GALVESTON COUNTY COMMISSIONERS COURT
GALVESTON COUNTY COURTHOUSE
722 MOODY (FIRST FLOOR) - GALVESTON
JUNE 21, 2011 – 1:00 P.M.

REGULARLY SCHEDULED MEETING – AGENDA – 1:00 P.M.

14. Consideration of Change Order No.1 to the Golden West Plastering Co. for Plastering for the Mid County Annex Project, submitted by the County Architect.

RFI- 115.1
4/19/11

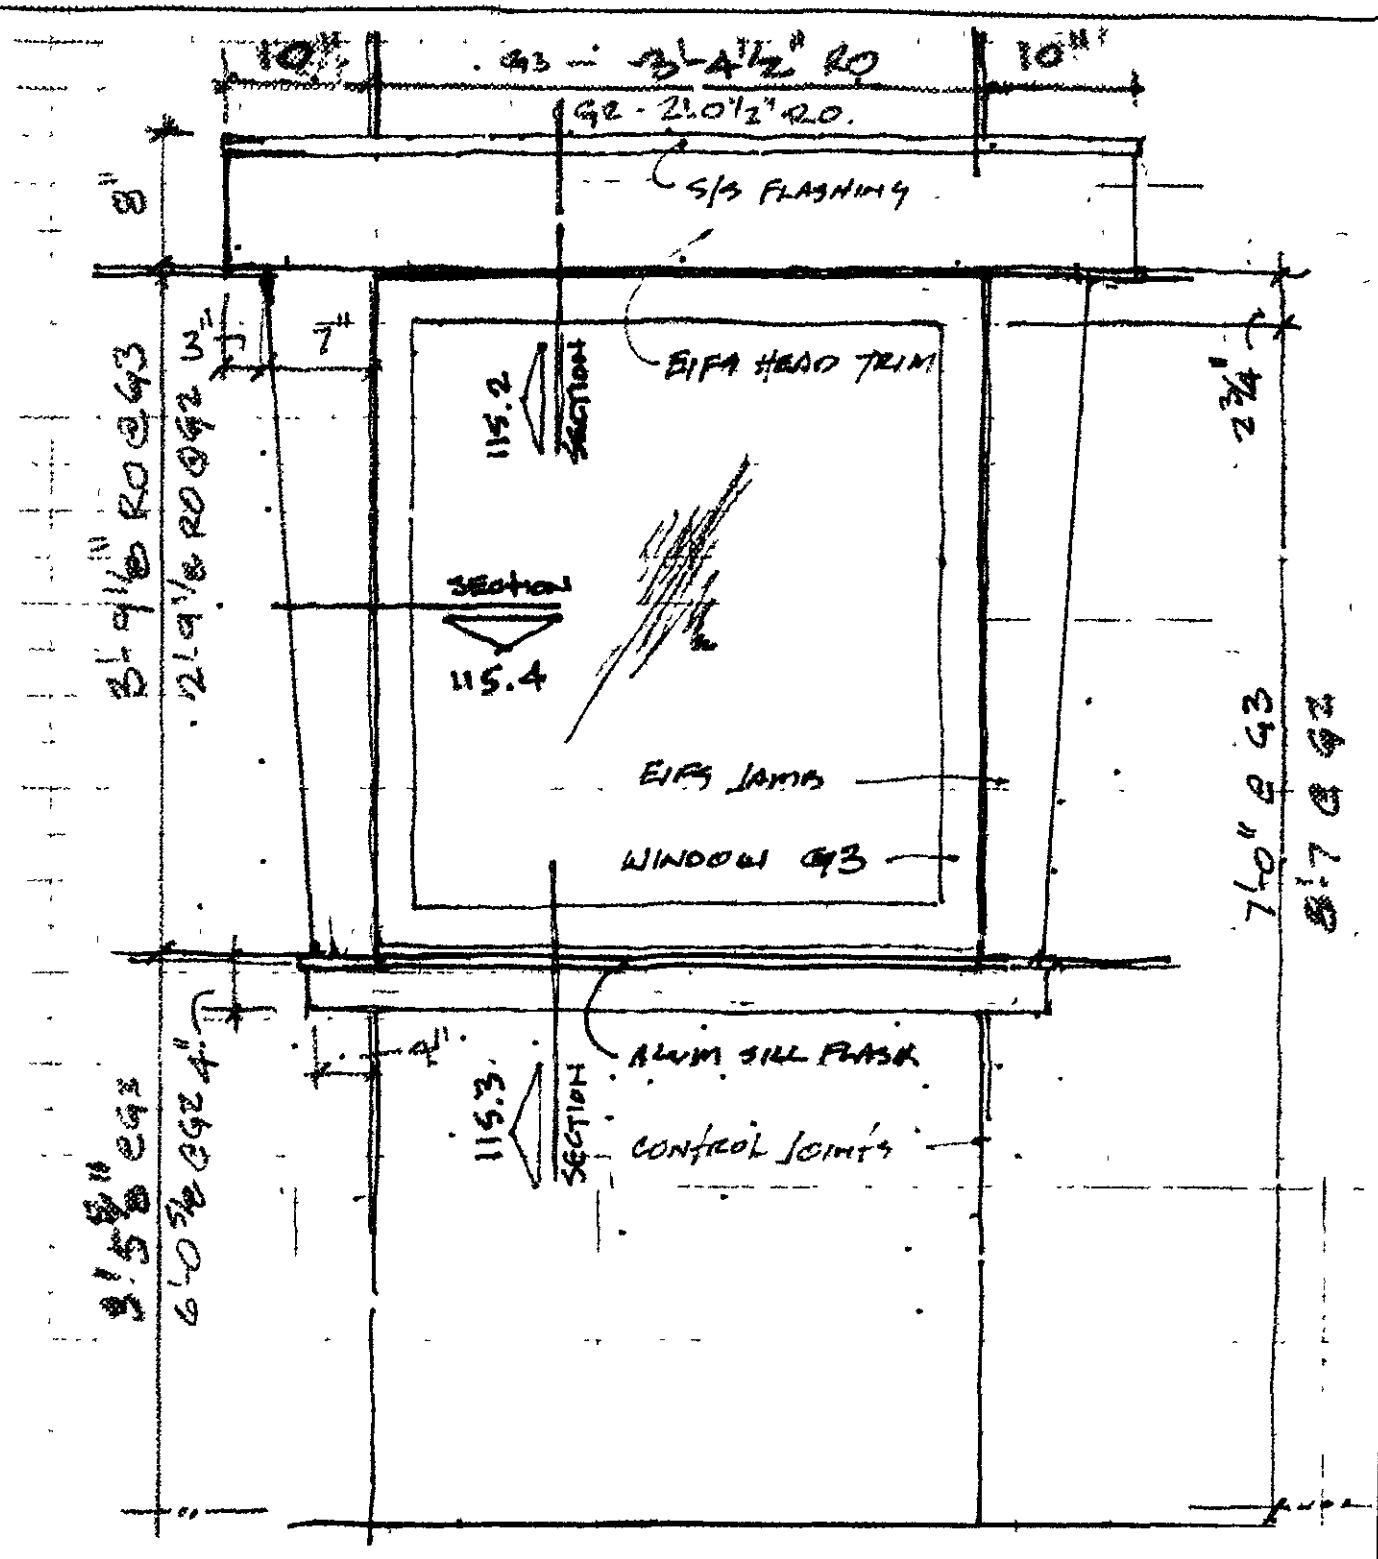
1) Please provide a detail to clarify window flashing and "eyebrows" where stucco covers lintels.

Response: 1) PLEASE SEE ATTACHED DETAILS 115.1 THRU 115.10 DATED 4/19/11.

RFI-124.1
5/4/11

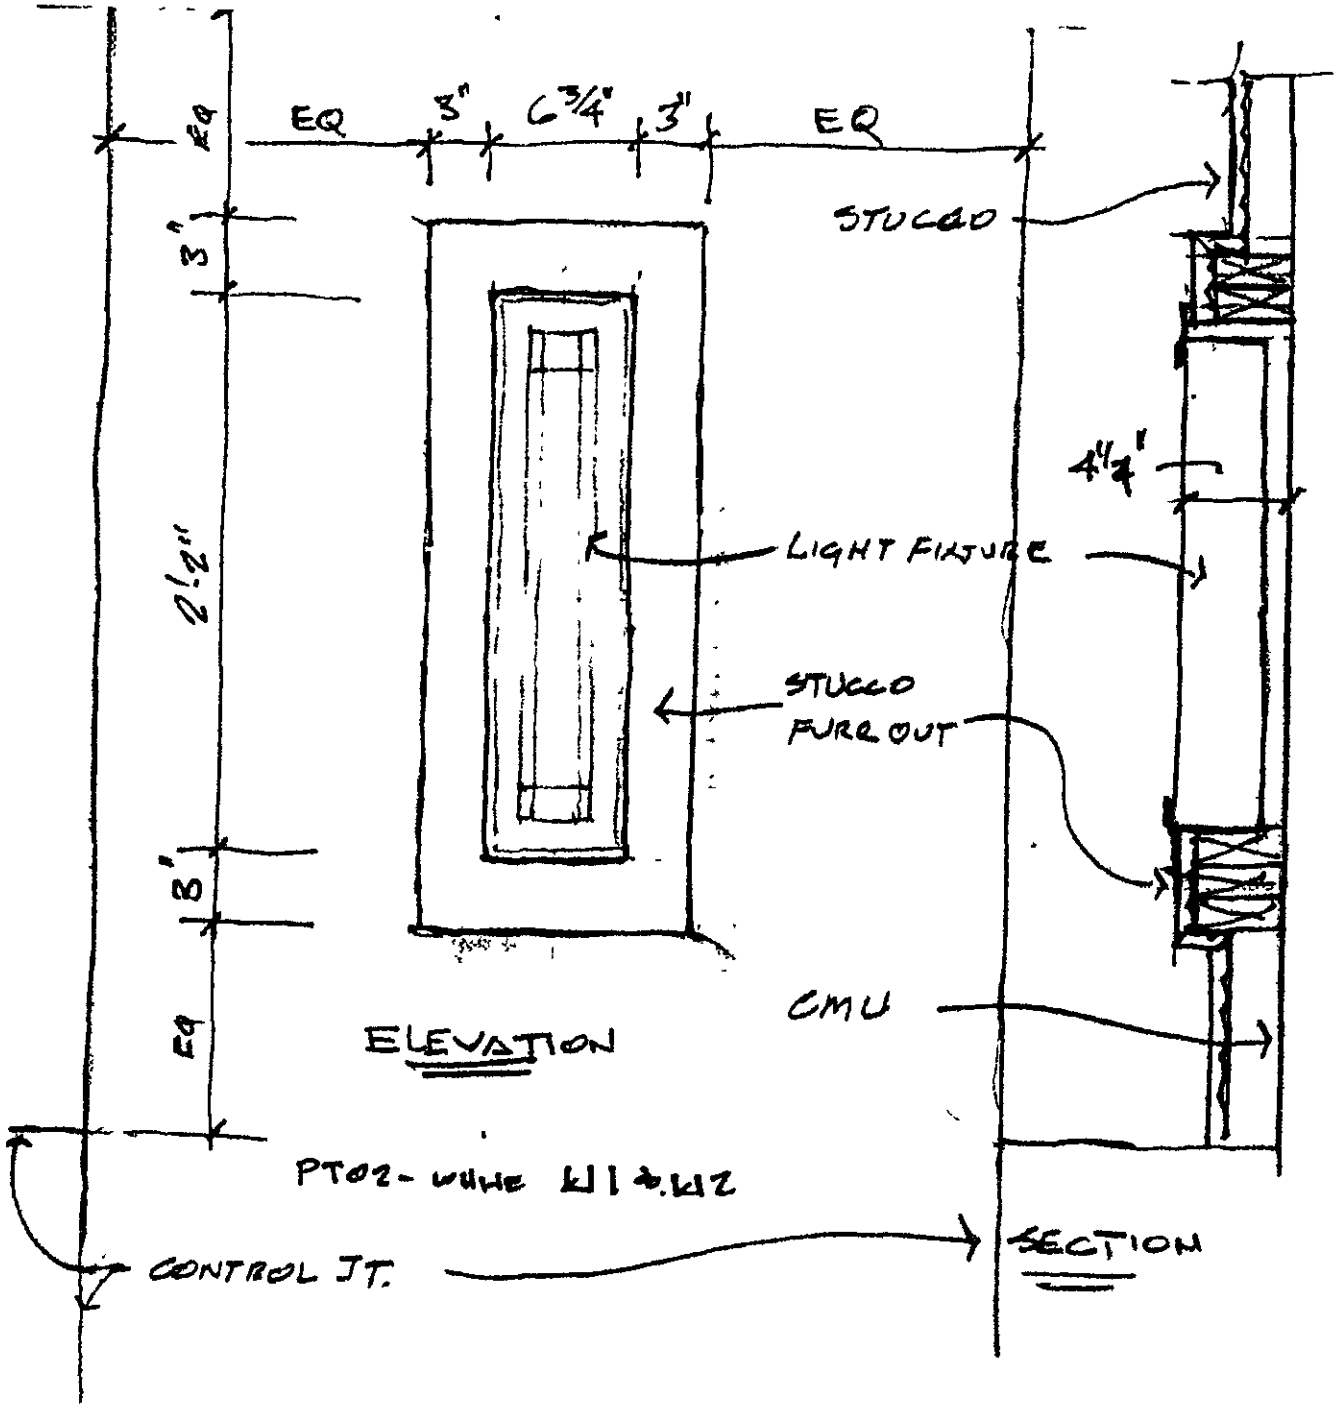
ITEM NO	DESCRIPTION OF CHANGE					INCREASE IN PRICE	DECREASE IN PRICE
1	**RFI 124** **Create stucco furr-outs over stud blocking (by others) at W1 light fixtures (28 locations) and W2 light fixtures (2 locations) per RFI 124.**					3,757.00	
	MATERIALS		**Quantity**	**Unit Price**	**Totals**		
	PC Scratch & Brown	Add	2 Bchs	31 81	63 62		
	Finish Acrylic Sand (StucCoat)	Add	1 Pails	50 51	50 51		
	Casing Bead, Zinc	Add	260 LF	0 89	231 40		
	Corner Bead, Zinc	Add	300 LF	0 80	240 00		
	15# Paper	Add	108 SF	0 04	4 32		
				Total Materials	**589.85**		
	LABOR (Burdens Included)						
	Lathers	Add	46 Hrs	33 50	1,541 00		
	Plasterers	Add	27 Hrs	33 50	904 50		
	Plaster Tenders	Add	9 Hrs	25 75	231 75		
				Total Labor	**2,677.25**		
	TOTALS			**Total Materials**	**589.85**		
				Total Labor	**2,677.25**		
				Total Costs	**3,267.10**		
				Markup	**490.07**		
				Total Price	**3,757.17**		
					TOTALS	3,757.00	
					NET CHANGE TO SUBCONTRACT	3,757.00

PLEASE SEE ATTACHED DRAWING 124.1
DATED 5/4/11 - NOTE: THE FURR OUT
FRAMING MAYBE METAL STUDS
